Your Reference SSD-77260958
Michelle Niles
Department of Planning, Industry and Environment
Via Major Projects Planning Portal

**Submission to SSDA
20-24 Railway Parade and No.2-4 Burleigh Street, Burwood
Mixed Use Development**

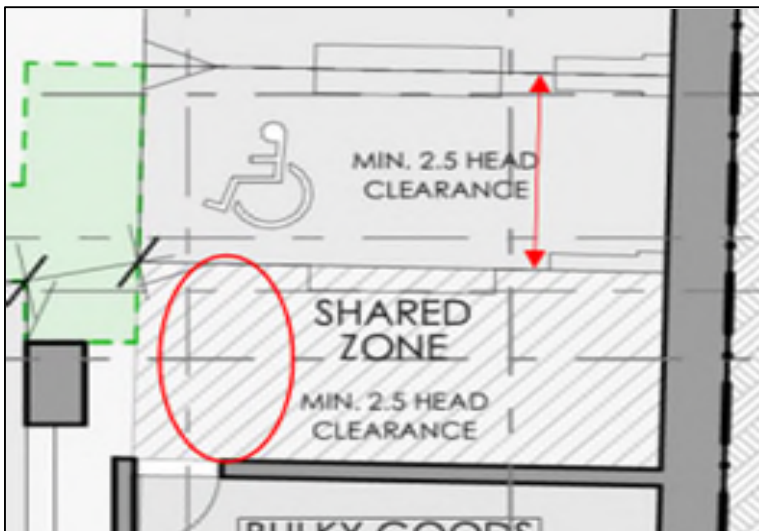
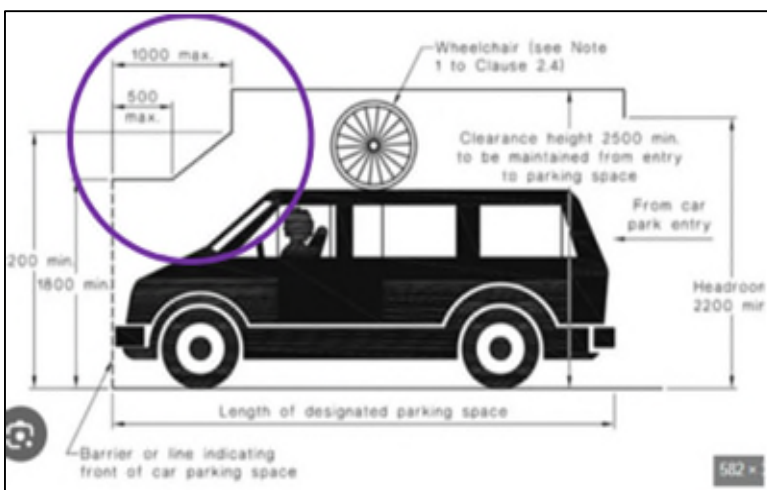
Design drawings SK08 P24, SK09 P24 and SK10 P24 do not show bollards in the shared space adjoining the accessible parking (allocated) space. In addition, dimensions are not shown for the accessible parking spaces (across all basement levels).

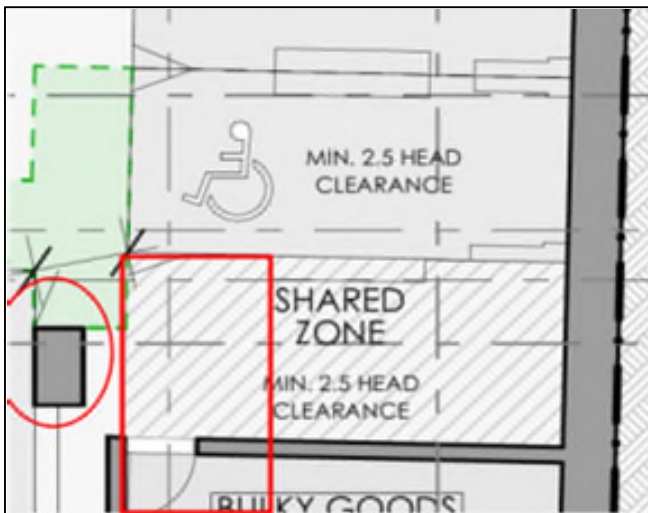
On drawing SK10 P24, there appears to be a substation pit above the accessible parking space. Recommendation for services designer/engineer to consider relocation of this pit. Otherwise, the construction of this space must be in accordance with AS2890.6-2022 – car parking spaces for disabilities

The construction of shared spaces must be designed to ensure that there are no impediments or encroachments into the shared spaces. The location of bulky goods and doorways leading into shared spaces can create unintended obstructions for the user of the accessible parking space. There is further obstruction from the location of support pillars (assumed).

In the above screenshot (western end of basement), there is only 1.021m of clearance between the edge of accessible parking space and the edge of adjoining parking space. The length of space and parking angle meant that a big utility vehicle, as is now common in Australia, will not only reduce the 1.02m clearance, and make it difficult to exit shared zone if there is concurrent access to bulky goods storage.

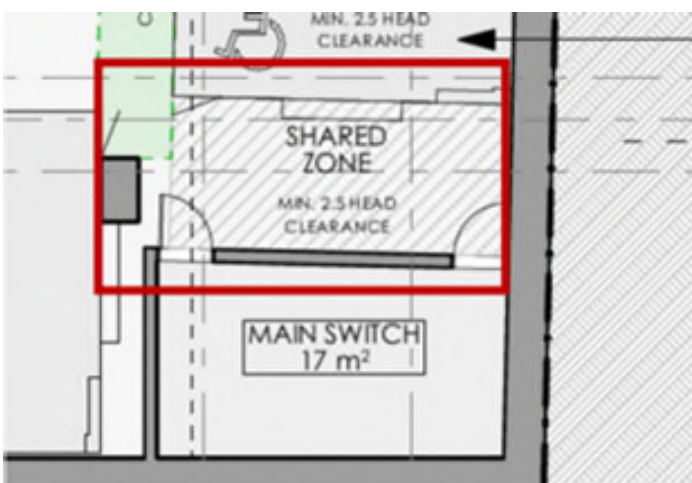
Basement 1-shared space for accessible parking space (eastern end of basement) is adjacent to a main switch room with two outward opening doors. It would be difficult to utilise this space with the first door being an additional obstruction in close proximity to a support pillar

Recommendation: Reconsider locations of all bulky goods storage. Reconsider the siting of

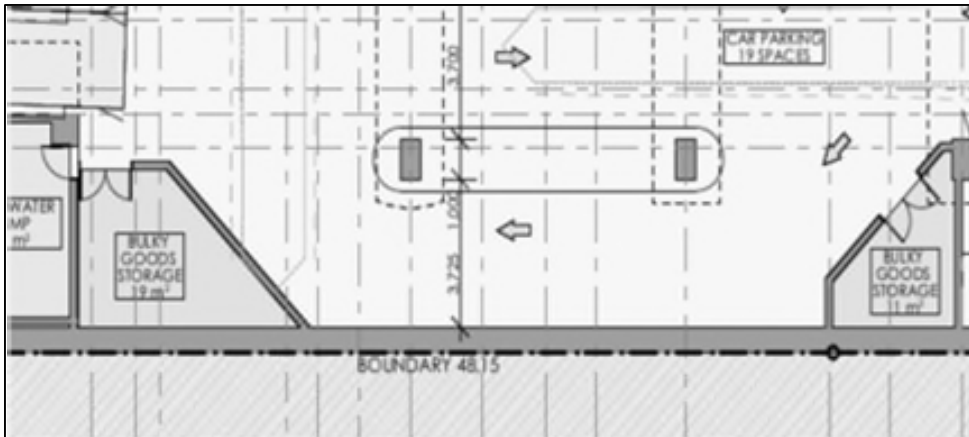
doorways to each storage and review the actual door width. The door widths are not compatible with the bulky goods storage – refer to Basement 1 drawing SK10 P24 (below) with double doors exceeding 850mm.

Ground Floor

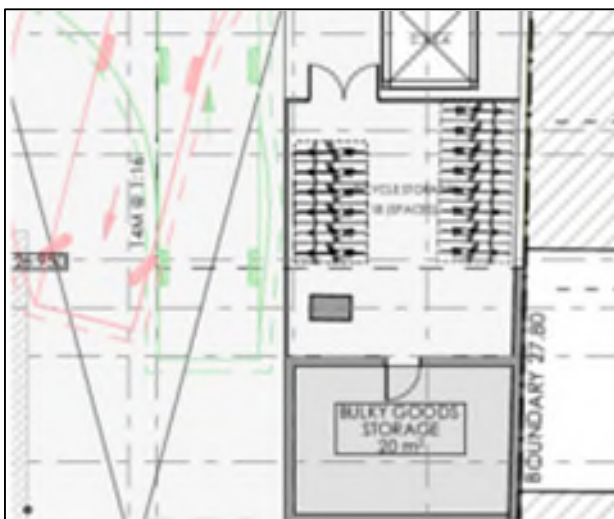
Ground floor level consists of residential access lobby, hotel and commercial offices lobby and supposedly a café (cannot identify location of café from drawing SK11 P24). Certifier to consider appropriate classification of each part of the building, and to make an assessment under NCC 2022 on fire safety.

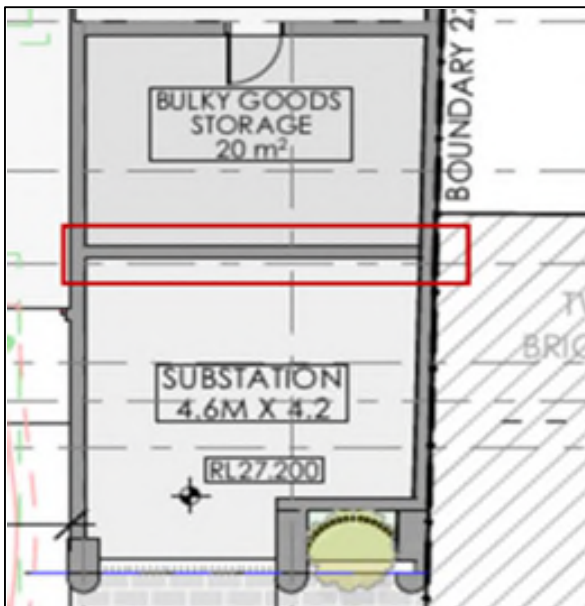
Fire separation for consideration by the certifier – wall between bulk goods storage and the substation. The bulky goods storage (depending on management of access) may contain hazardous goods such as a portable BBQ.

Fire Separation Between Floor Levels

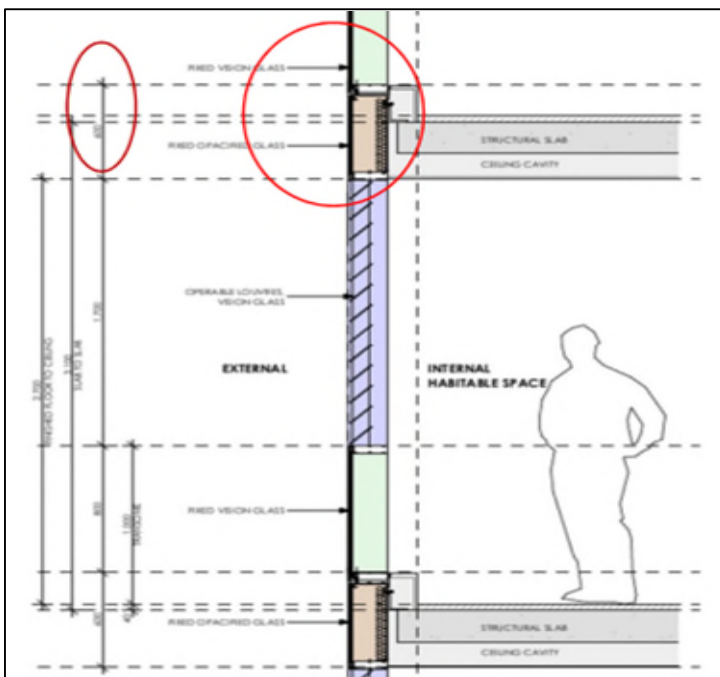
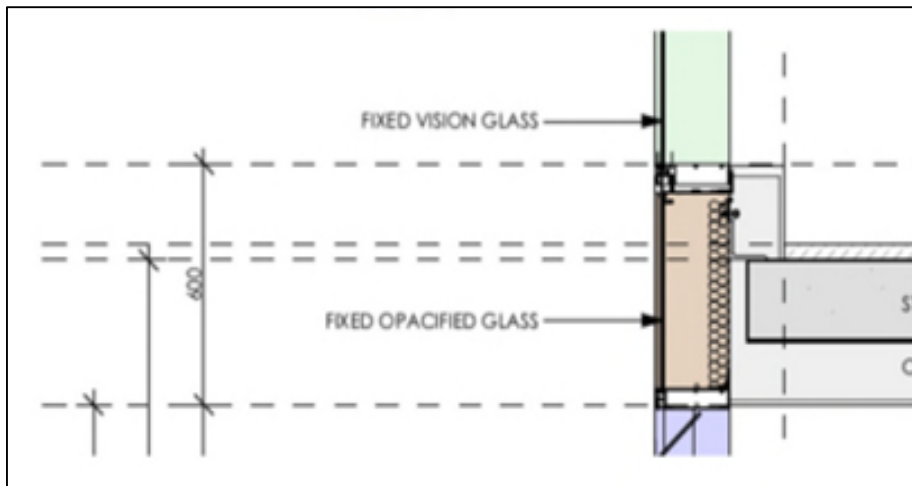
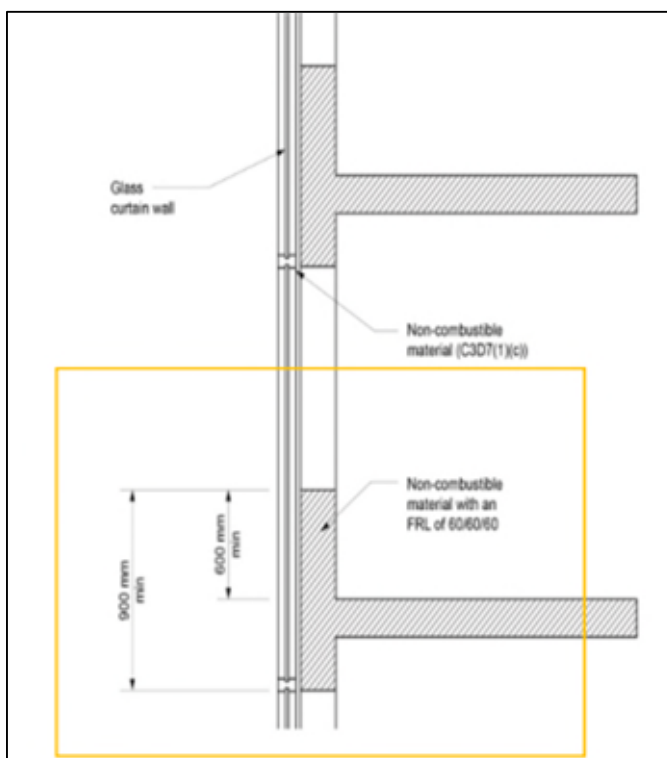
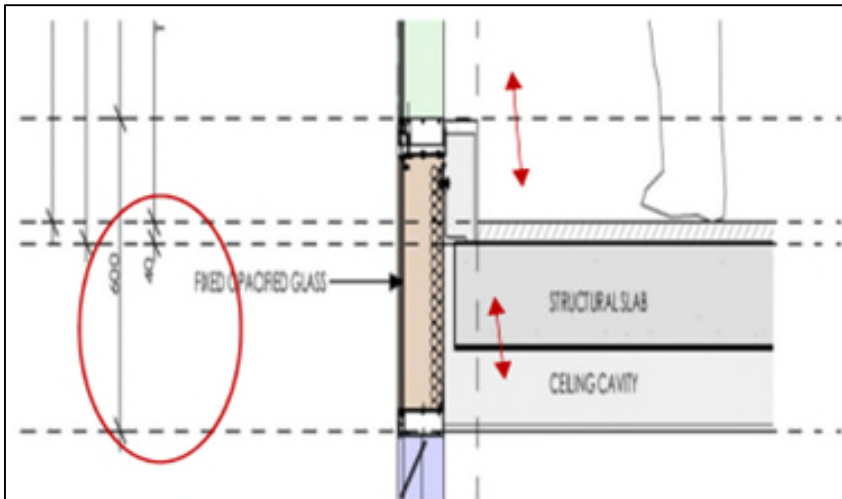
Notwithstanding Council's concerns with glazed façade, inadequate design details for curtain walls are shown.

Minimum design considerations as per NCC 2022 Volume 1 for the application of spandrels, or curtain walls that are utilized for this proposed development.

Separation of external window openings to prevent spread of fire between levels must cover 900mm, with 600mm at minimum from the edge of floor above. Red arrows are critical information gaps where it is unknown how this curtain wall design will achieve compliance, or a performance solution warranted for the proposal.

The transome is 1000mm, and fixed vision glass is 800mm. Subtracting the fixed vision glass from transom leaves 200mm. **200mm of opacified glass, fixings and 40mm of flooring meant that the curtain wall construction has vertical protection (assumed) to 240mm.**

This meant 360mm of the minimum 600mm vertical protection is non-compliant.

There is no detail whether the material behind fixed opaque glass is non-combustible, including the structural slab and extent of fire resistance for those materials shown.

Plant Rooms and Level 19 and Level 32

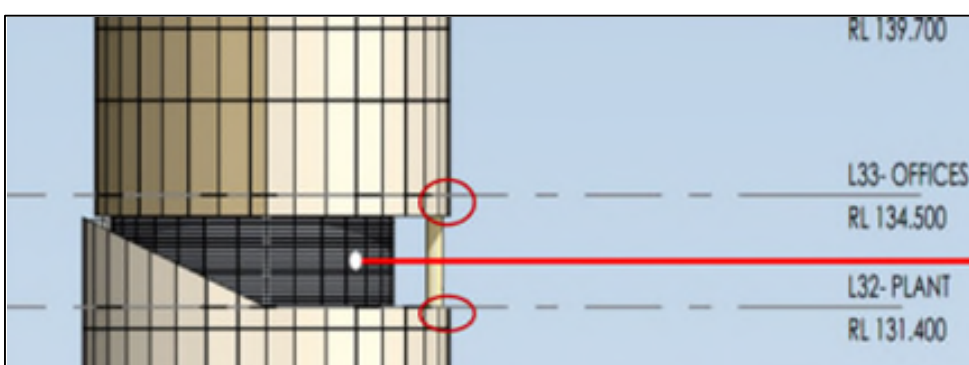
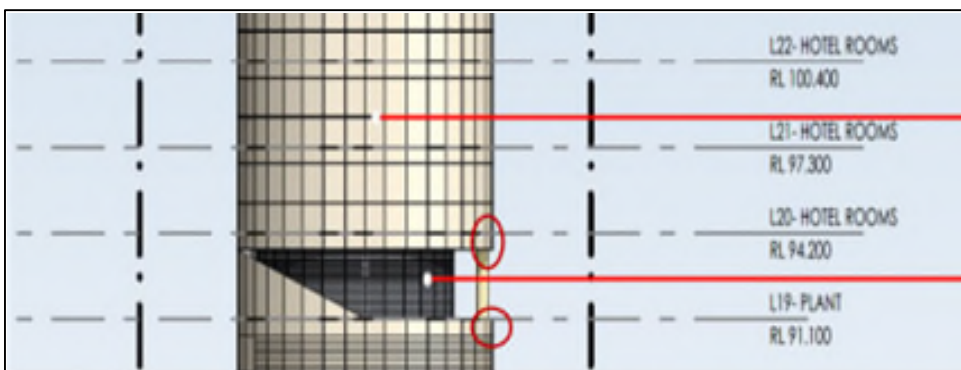
Design details for separation between levels are not included specific to spread of fire to the hotel or offices parts of building. Generally, a spandrel would be required at the top and bottom edges of both Level 19 and Level 32 plant. Or a curtain wall construction as designed for this proposed development.

Consideration is required for fire separation and management of hazards arising from entire floor level used for plant / utilities prior to issuing construction certificate.
